MEMORANDUM

OFFICE OF COMMUNITY DEVELOPMENT

APPLICATION FOR APPROVAL OF A 3-LOT SUBDIVISION  
31 HOPEWELL ROAD—CHURCHILL SUBDIVISION  
MEETING DATE: JUNE 15, 2021

Re: Churchill Subdivision  
31 Hopewell Road

Churchill  
SUBDIVISION  
SIDEWALK MASTER PLAN

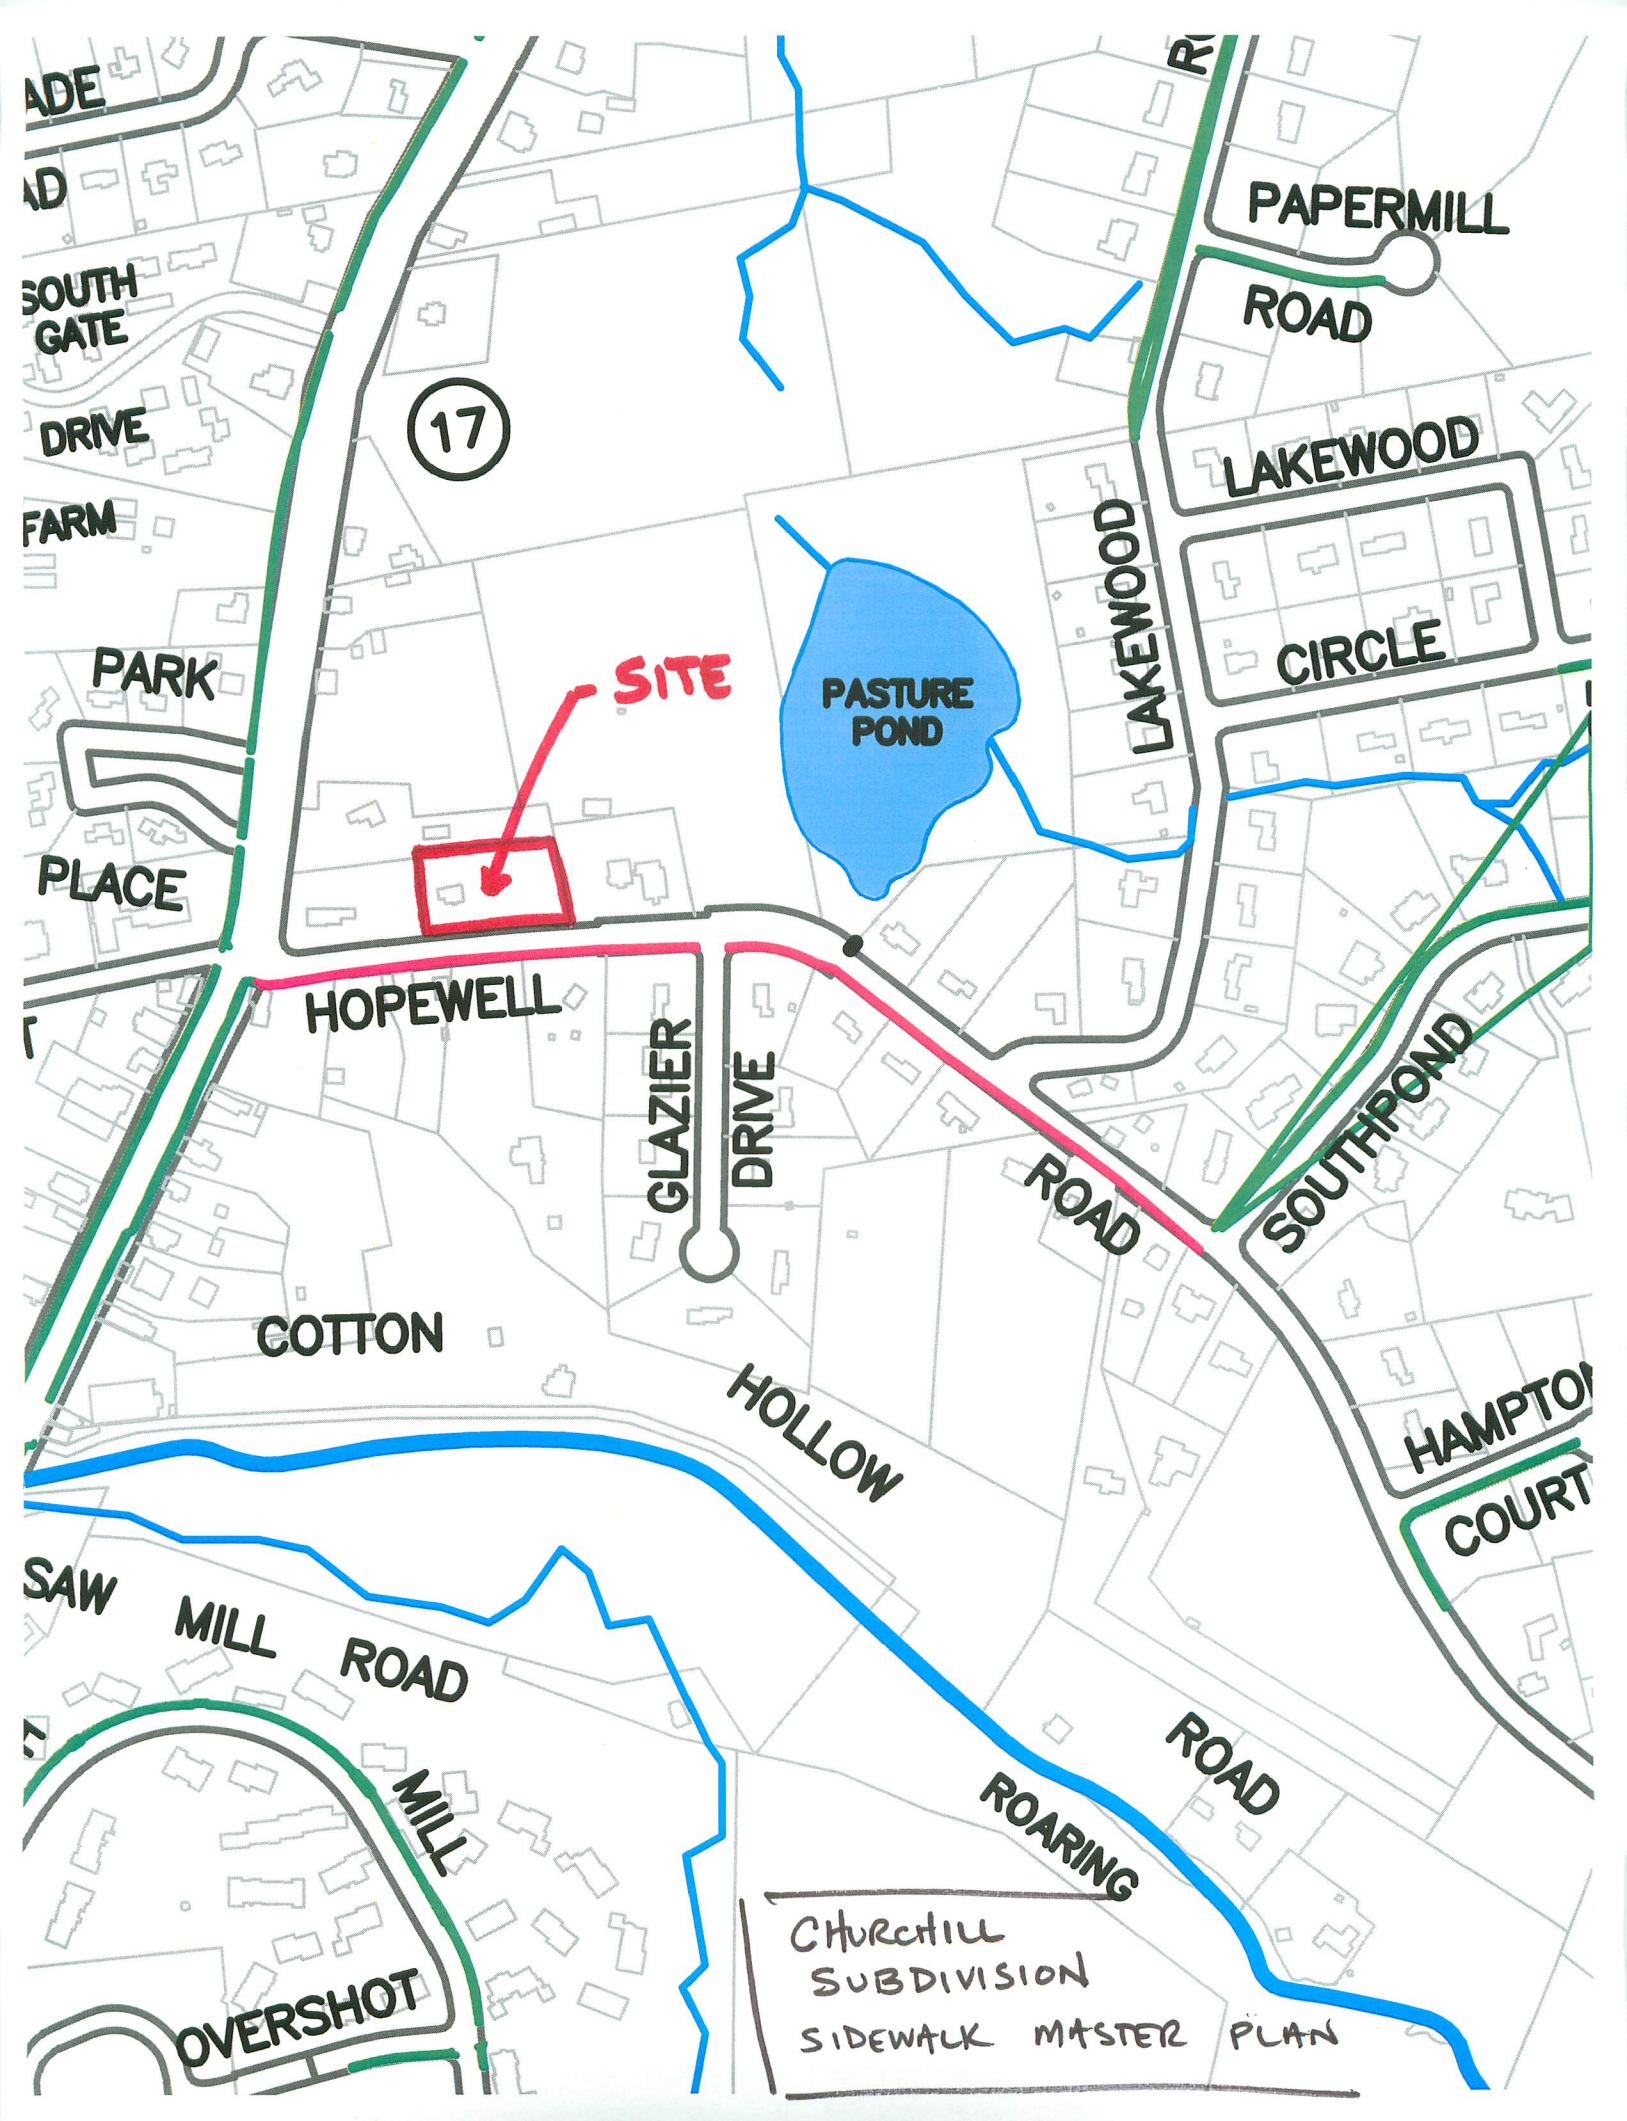
Sidewalk construction was discussed with the Glastonbury Engineering Department, indicating that the Town's Sidewalk Master Plan designates sidewalks to be constructed in the opposite side of Hopewell Rd. in this area. The reason for construction on the South side is due to connections with the existing sidewalks and existing crosswalk on Main Street, connection to Glazier Drive and topography along the frontage of St. Augustines Church. Please see the attached portion of the Sidewalk Master Plan.
